IDAHO DEPARTMENT OF WATER RESOURCES
RECOMMENDATION OF WATER RIGHTS ACQUIRED UNDER STATE LAW

RIGHT NUMBER: 63-9587
NAME AND ADDRESS: STATE OF IDAHO
DEPT OF LANDS
300 N 6TH ST STE 103
PO BOX 83720
BOISE ID 83720-0050

Post-review follow up issues for IDL claims in basins 61 and 63.

Review notes for recommendations of late claims filed by IDL.
Sent as an attachment with email to IDL attorney, Tyson Nelson.
Steve Clelland – May 1, 2013

63-09587

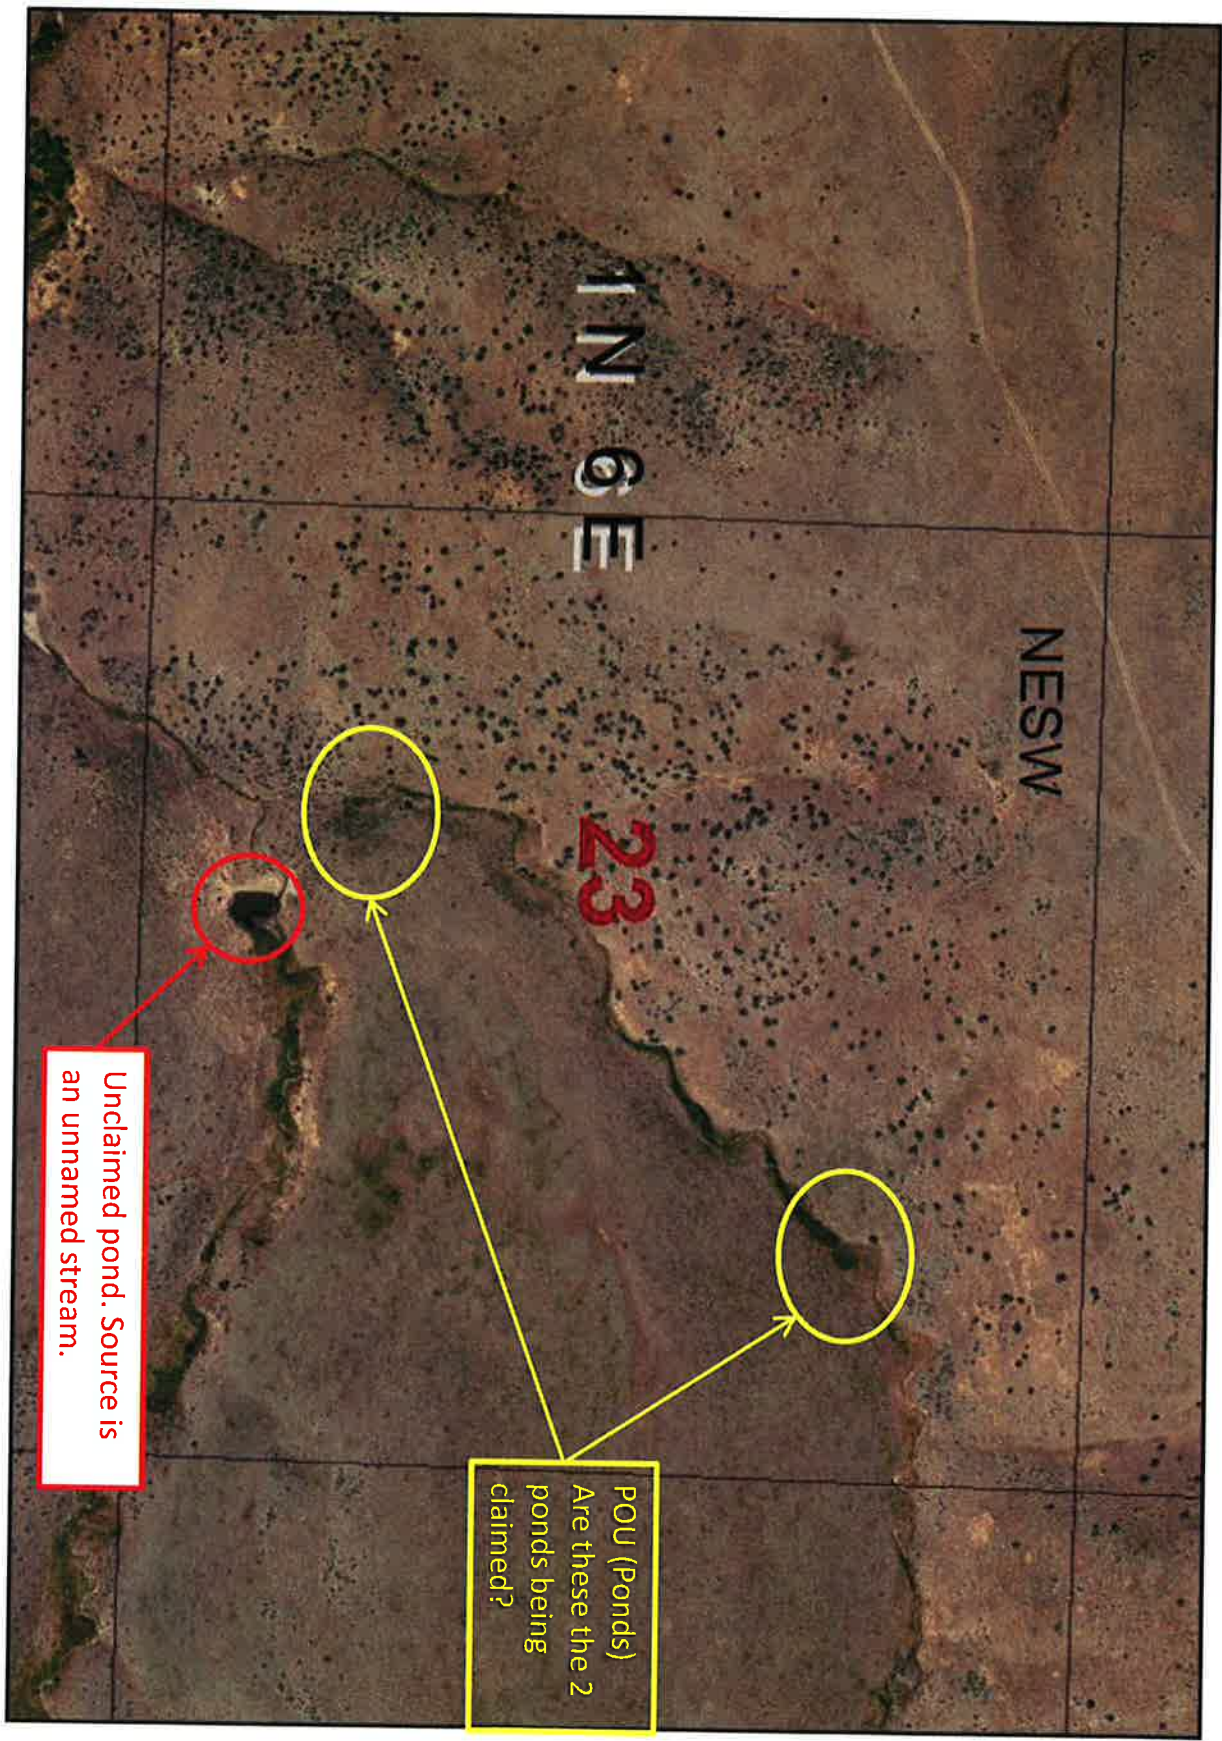
Claimed

POD: T01N, R06E, S24, SWNW
POU: T01N, R06E, S23, NESW

Aerial photography shows 3 ponds
in T01N, R06E, S23, NESW.

The application for permit for this right describes water being diverted from a spring in T01N, R06E, S24, SWNW and piped approximately 3,400 ft to a trough in T01N, R06E, S23, NESW, and then piped from that trough approximately 900 ft more to another trough also located within T01N, R06E, S23, NESW.

Aerial photography does not show any troughs, but does show what could be 2 ponds. This claim was licensed with 0.20 AF of storage suggesting that the troughs could actually be ponds/reservoirs. If these 2 ponds are what the claimant is claiming then there are no issues with the claim.

63-9587

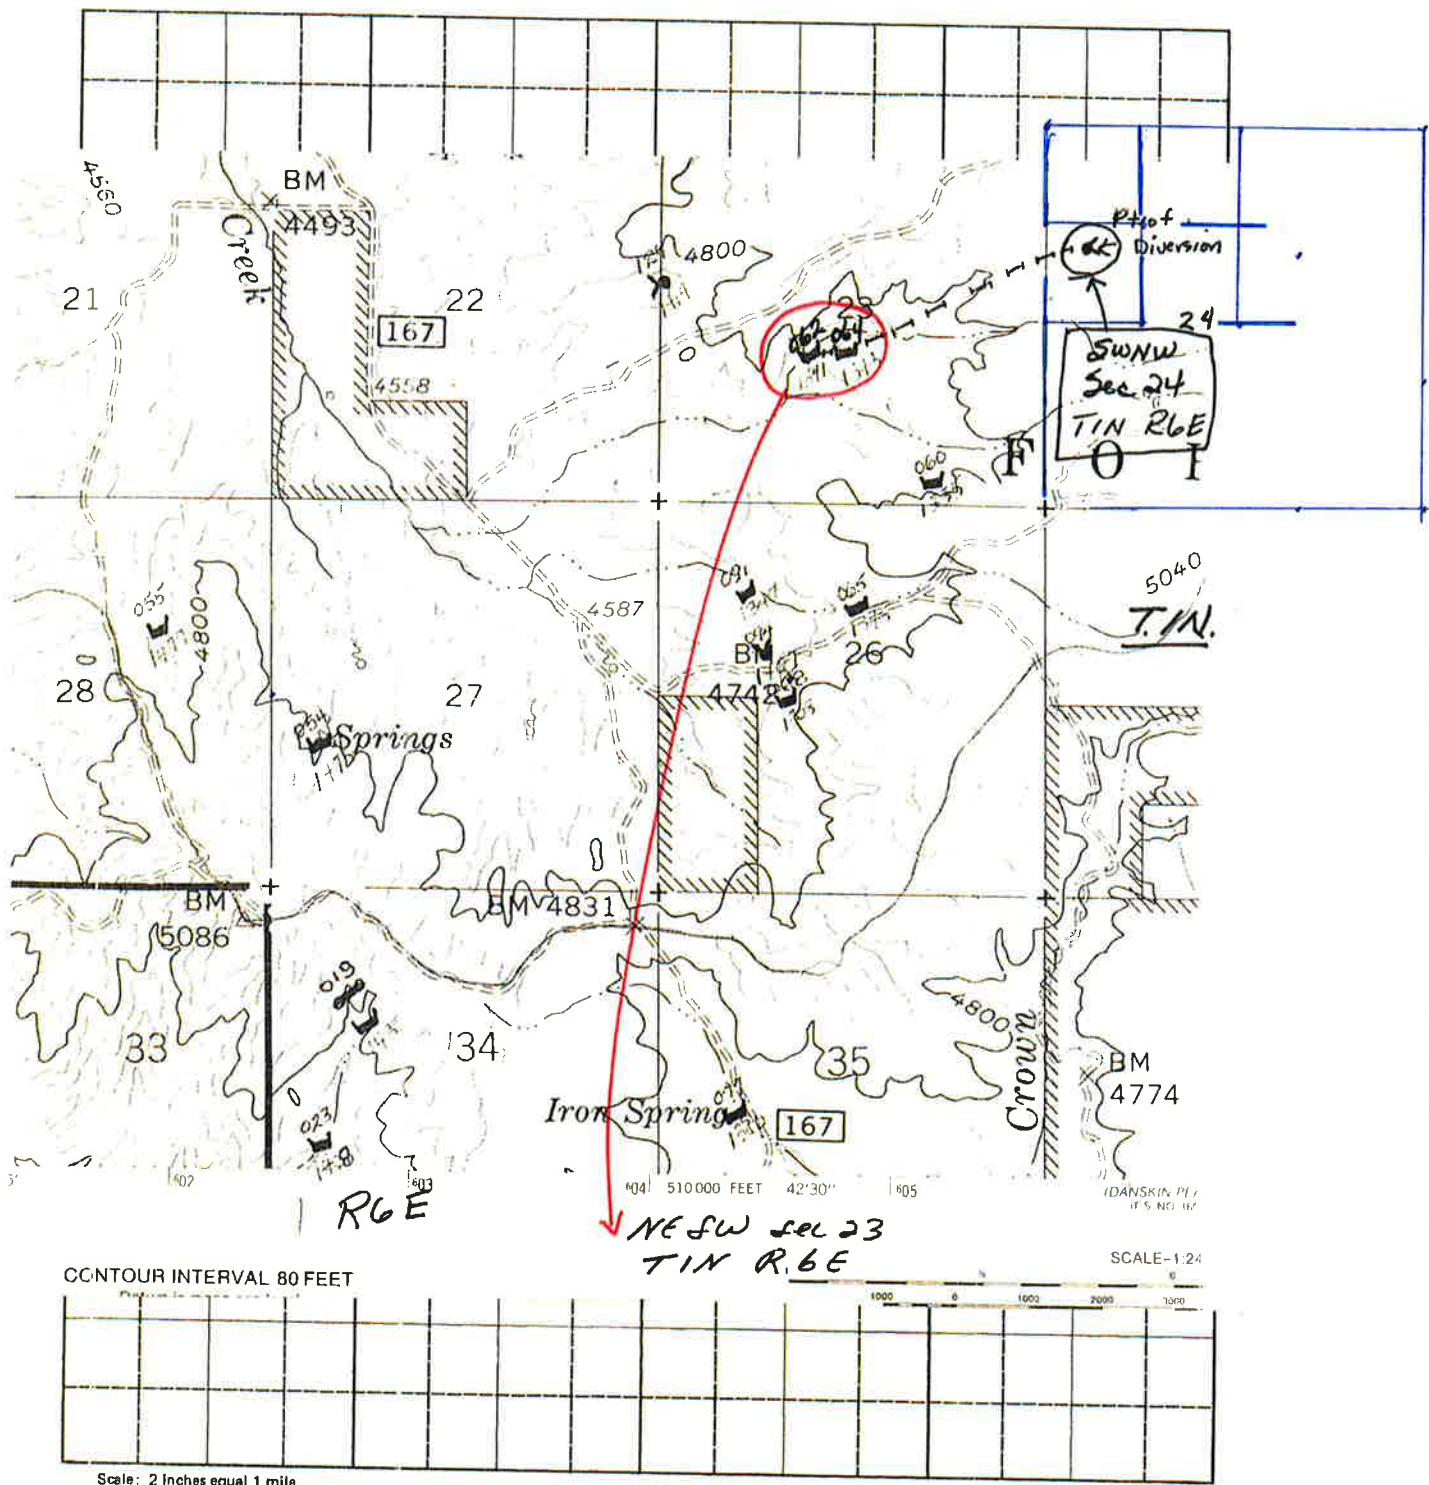
TOD Location is very difficult to identify
based on Backfile.

Perhaps pipe length can pinpoint the site
Given 3400 feet of pipe between Source & Trough
900 ft to 2nd trough (062) (064)

Need more info from IDL... info doesn't match up.

IDL update w/ GPS data

PDD/POU located in S. 24 NWSW.

Pipeline is Abandoned.

S. 23 tanks Removed,
No POU in S. 23
